City of Gig Harbor Design Review Board Virtual Meeting of October 13, 2022 at 5:00 pm

STAFF REPORT

Re: 3555 Erickson Development (PL-DR-22-0047)
Public Meeting Date: October 13, 2022

SKA4.2

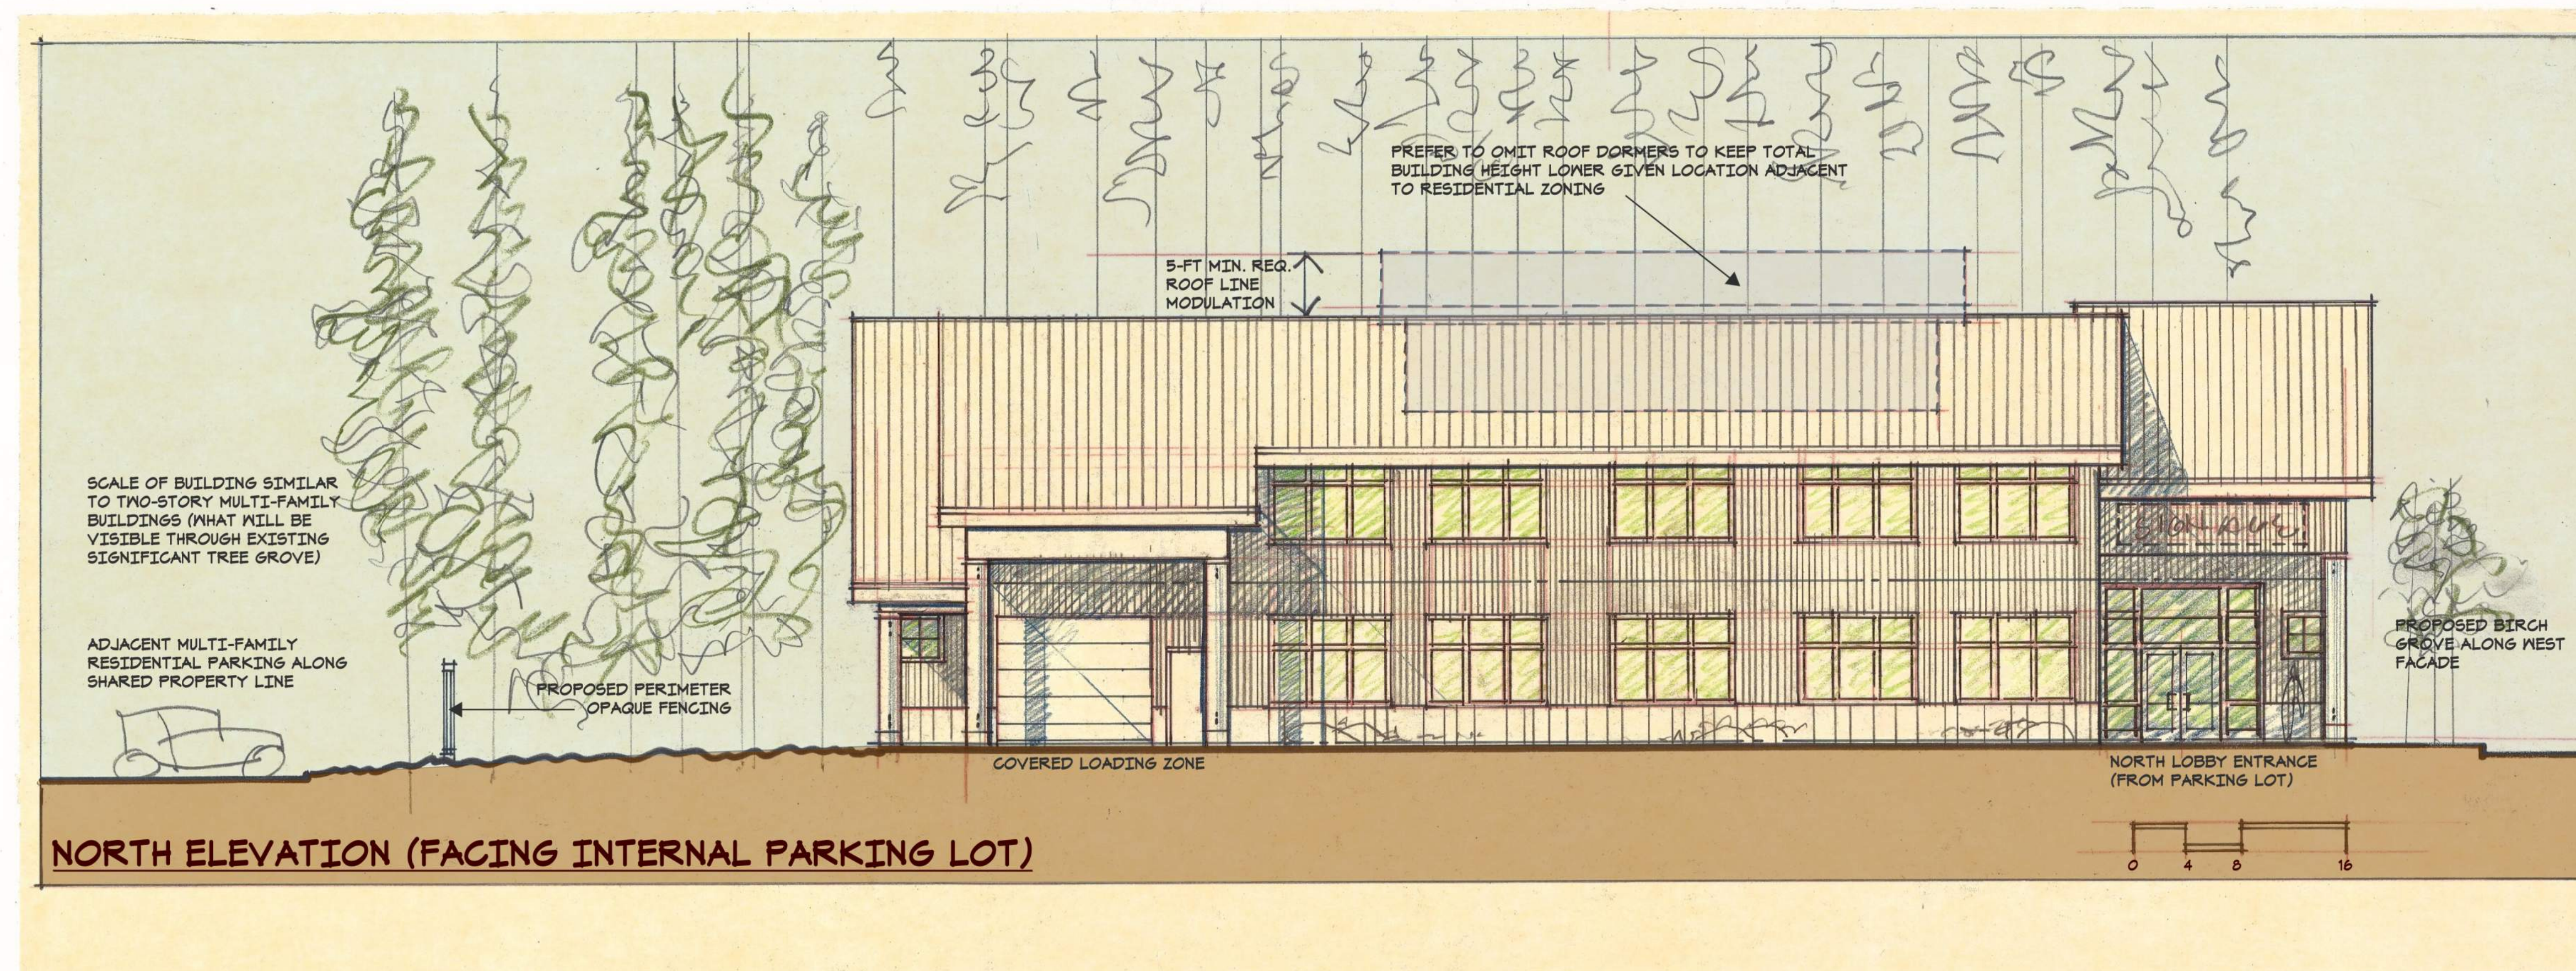
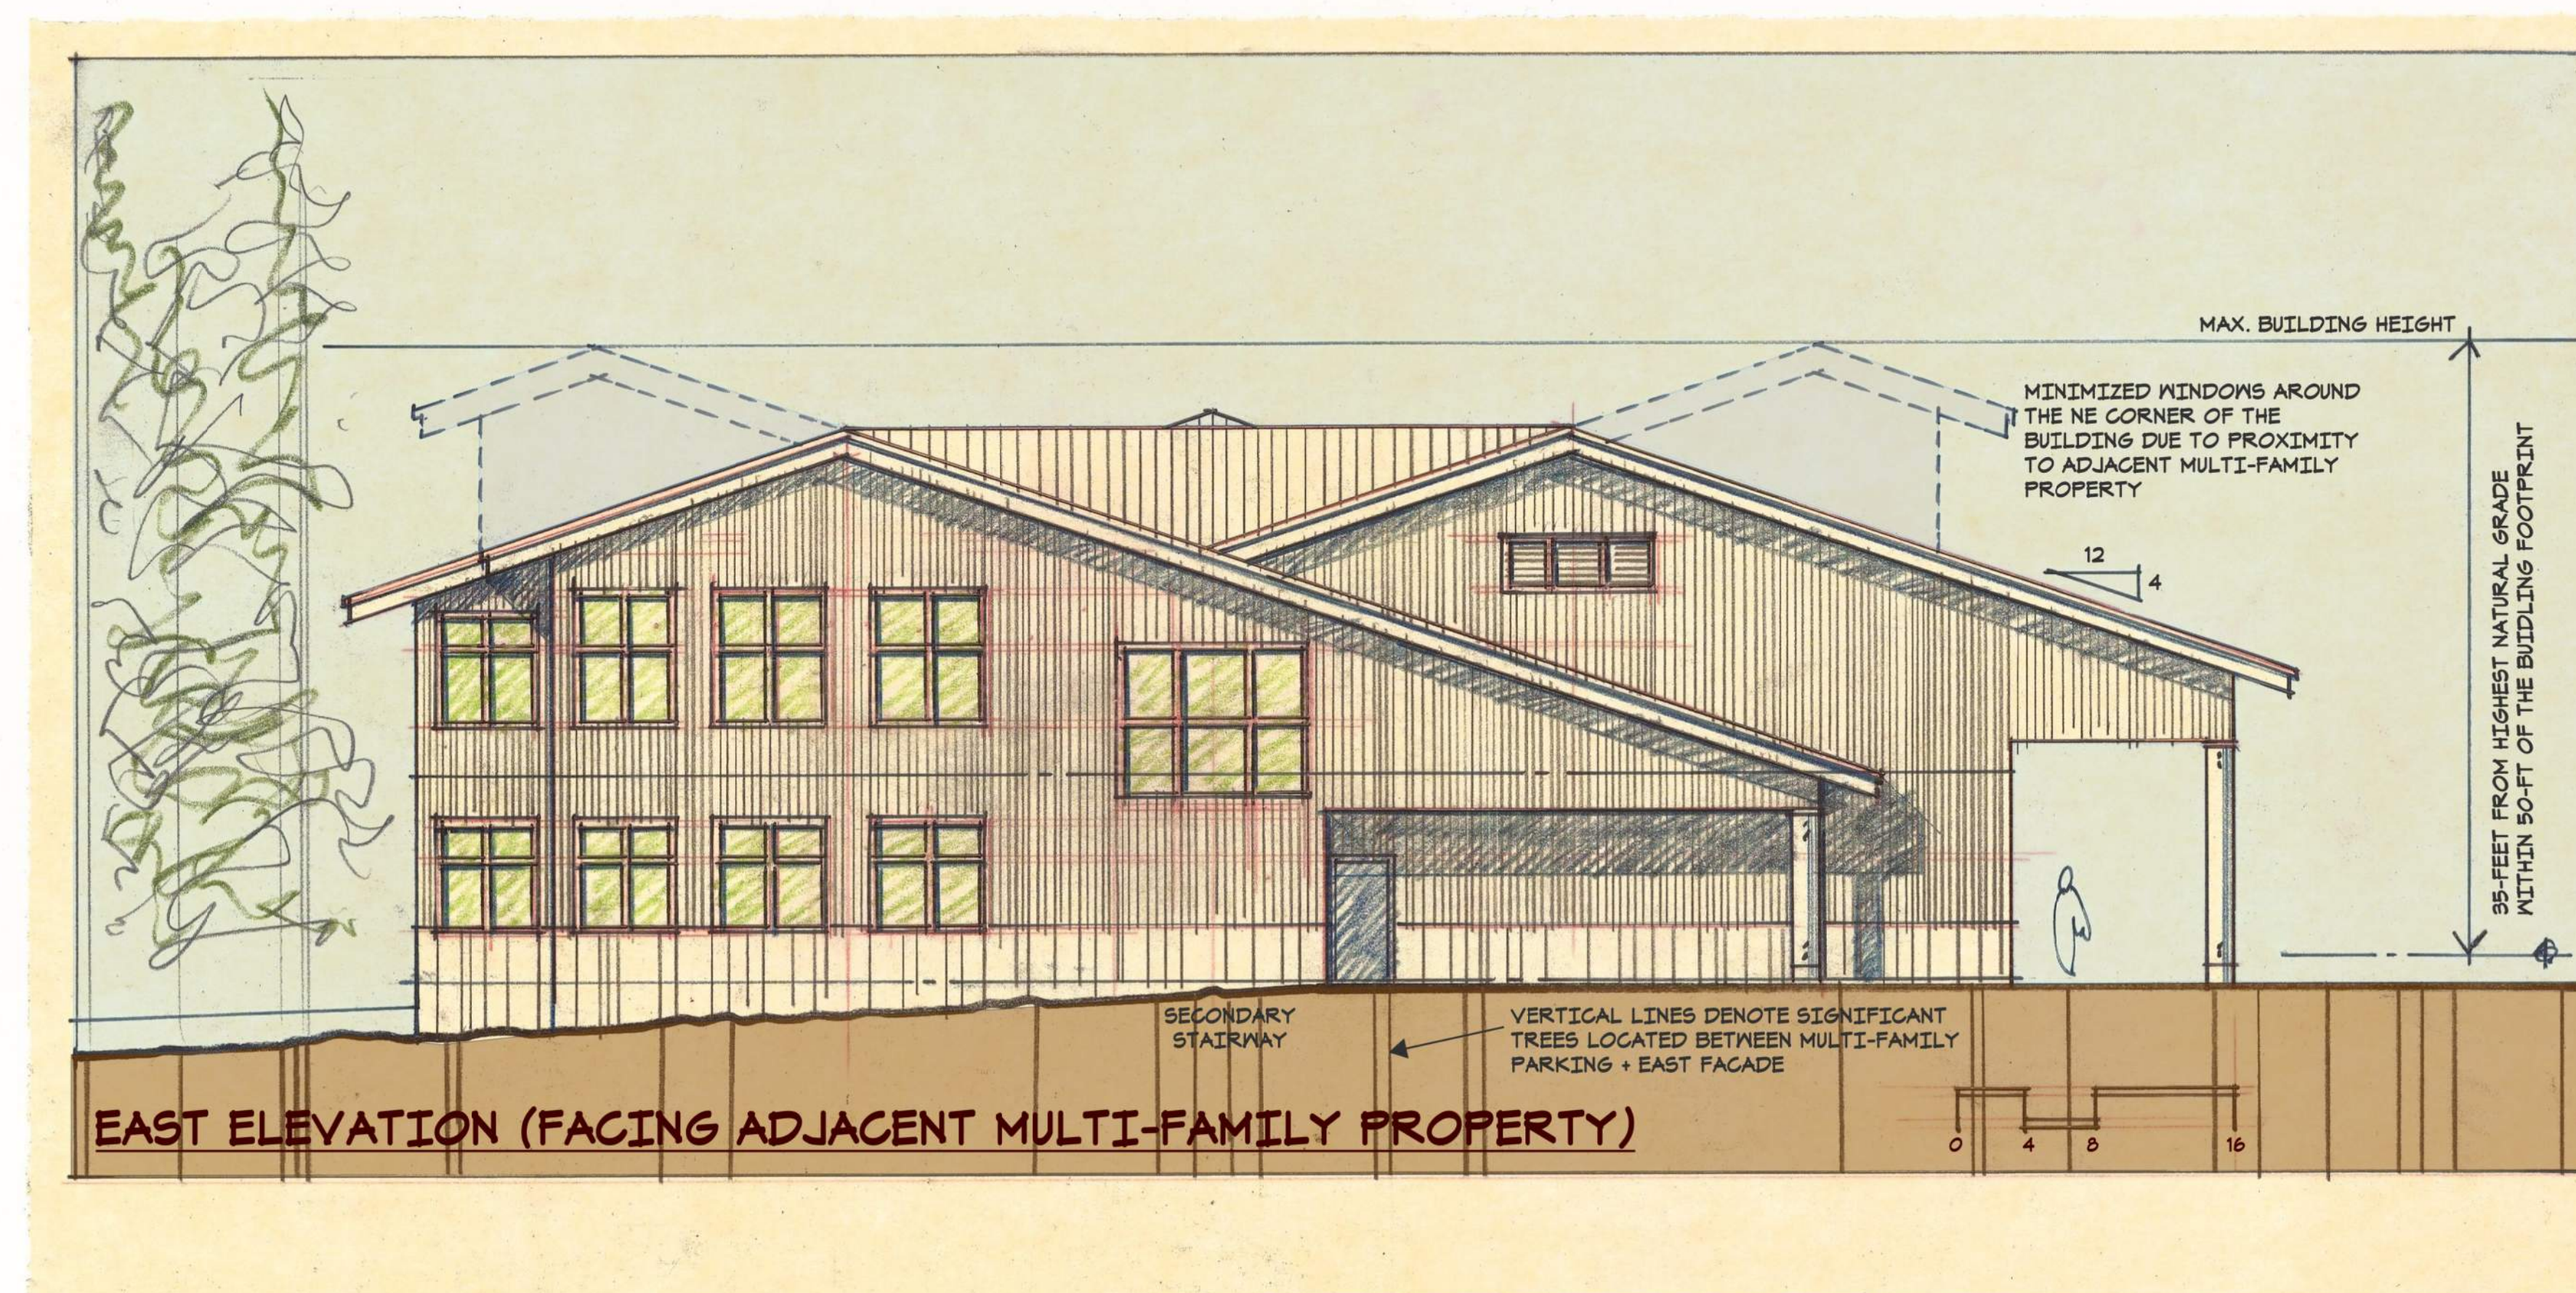
It is not clear that the proposed roof lines meet this requirement. Notes on the submitted elevations indicate the applicant prefers to omit roof dormers to maintain building height, however the north elevation in particular does not appear to meet the requirement to shift the roof line.
